Development Review Committee Staff Report

Case No:	14DEVPLAN1148
Project Name:	New Parking Lot for Portland Elementary School
Location:	3418 and 3420 Pflanz Avenue
Owner(s):	Board of Education of Jefferson County
Applicant:	Same
Representative(s):	John Addington, BTM Engineering
Existing Zoning District:	UN
Existing Form District:	TN
Jurisdiction:	Louisville Metro
Council District:	5 - Cheri Bryant Hamilton
Case Manager:	Sherie' Long, Landscape Architect

Community Facility Review (CFR) for construction of a new parking lot for Portland Elementary School.

Attachment 4: Site Plan

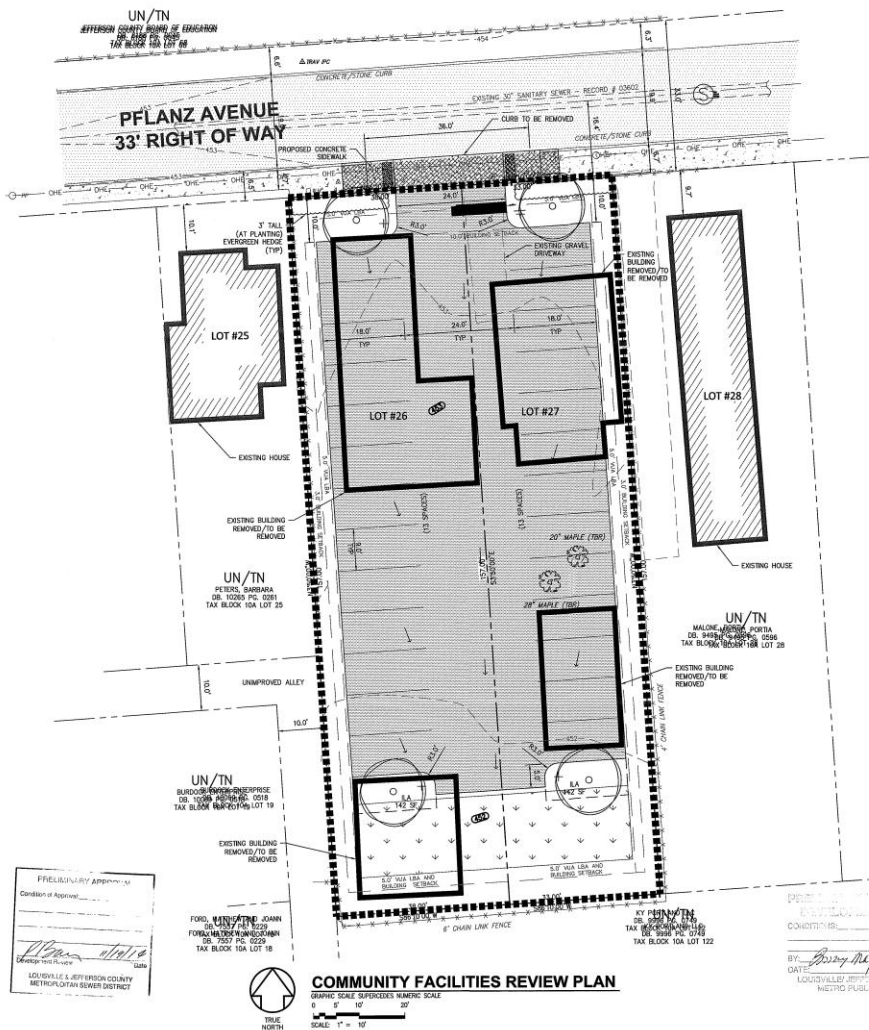
Currently there are two large existing trees located along the eastern perimeter near the rear of the property which could be saved if the parking lot were modified to accommodate them to remain. However, the proposed layout of the parking lot does not take into consideration preservation of these existing trees.

The plan does not show the locations of any proposed light poles or lighting fixtures; however the plan does contain a note addressing lighting, which is to be directed down and away from neighboring properties.

MSD has reviewed the development plan for drainage compliance. The applicant has been advised to provide an infiltration trench, or bio-swale which will accommodate the increased storm-water runoff generated by an increase of impervious surface area. However, the development plan does not reflect or relay either an infiltration system or bio-swale to address the increased runoff. The plan does contain notes referencing a detention basin along with drainage pipes and channels which will be designed to conform to MSD standards and specifications.

1. The planting requirements of the 5' LBA along the West, South, and East perimeters are not being met. Seven Type A or B trees along with a 6' screen (wall, solid fence, plantings, or combination of these) are required in the 5' LBA. A waiver would normally be required.

2. A 3 foot masonry, stone or concrete wall that makes reference to a similar design within the surrounding area shall extend across the front of the parking area. A waiver would normally be required.

4. A 5' LBA is required along the common lot line between the two lots. A waiver would normally be required to eliminate this requirement; or the two lots could be consolidated which would eliminate the property line, therefore eliminating the buffer requirement.

5. The parking lot is required to be accessed from the existing Alley(s). A waiver would normally be required.
6. MSD's recommended storm water method of an infiltration system or bio-swales are not shown or addressed on the plan. Drainage is approved during the construction review and approved process.
